**ZONNEQUA WIND FARM GRID CONNECTION (KLEINSEE, NORTHERN CAPE):  
APPLICATION FOR AMENDMENT OF THE ENVIRONMENTAL AUTHORISATION  
AVIAN SPECIALIST COMMENT – 2021**

This specialist comment is relevant to the proposed (2021) amendments for the grid connections for the authorised Genesis **Zonnequa** Wind (Pty) Ltd's Wind Farm near Kleinsee and its likely impact on the avian community. Avian impacts along the grid connection from the Gromis Substation to the Namas and Zonnequa wind farms were assessed in 2017-2018 (Simmons and Martins 2018) and several priority bird species that may be impacted by the wind farm were found to use the area.

**Figure 1:** The change in the proposed 132 kV grid connections: (i) corridor width (300m to 600 m) to the Gromis substation (top), and (ii) the increased size of the corridor into the Gromis substation.

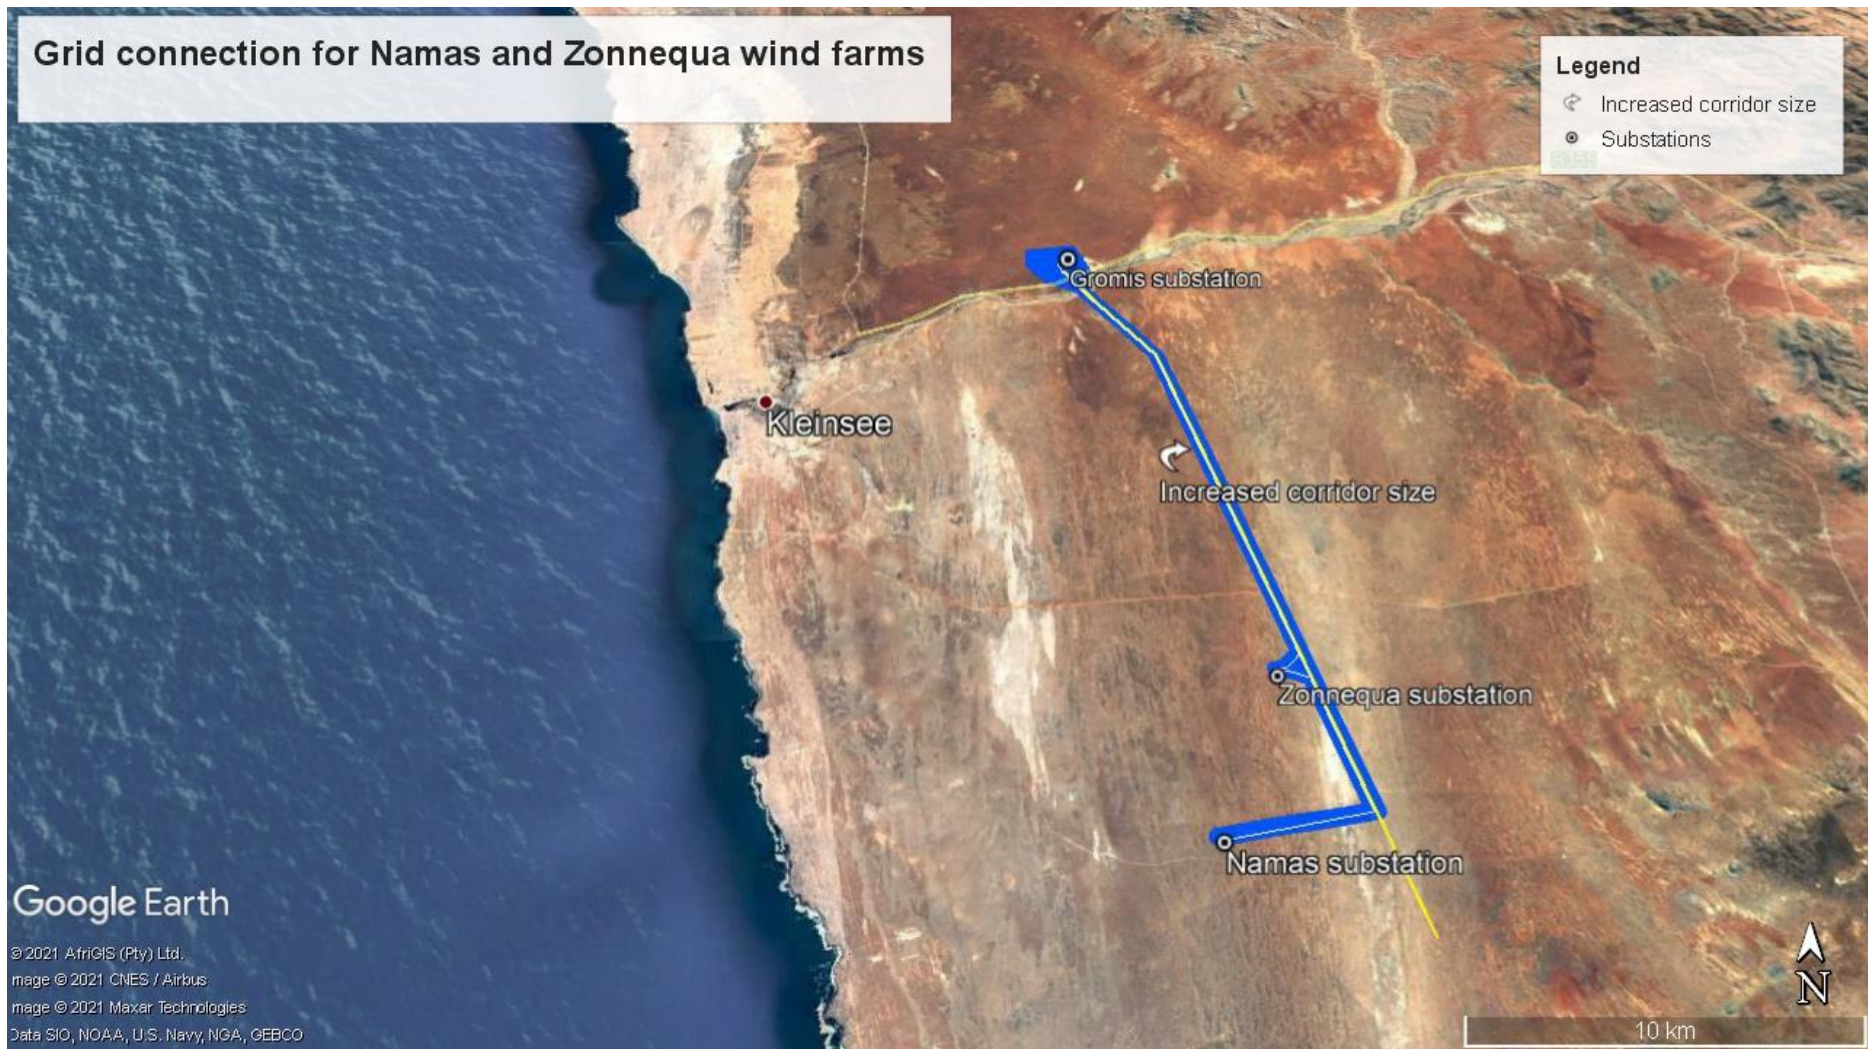
The new amendment proposes that the width of the approved corridor increases from 300m to 600m in width for the length of line from the Gromis substation to the Zonnequa on-site substation (blue in Figure 1). Given that the power line exporting the energy from the two wind farms will still lie adjacent, and the pylons staggered, to the proposed 400 kV line, the risk to birds, particularly the collision-prone bustards will not change. This is because the alignment next to the proposed 400 kV line will remain (whatever side it is placed – east or west) and that provides increased visibility of the two lines from the staggered pylon effect and the addition of bird diverters to both lines will increase visibility, and decrease avian risks, further.
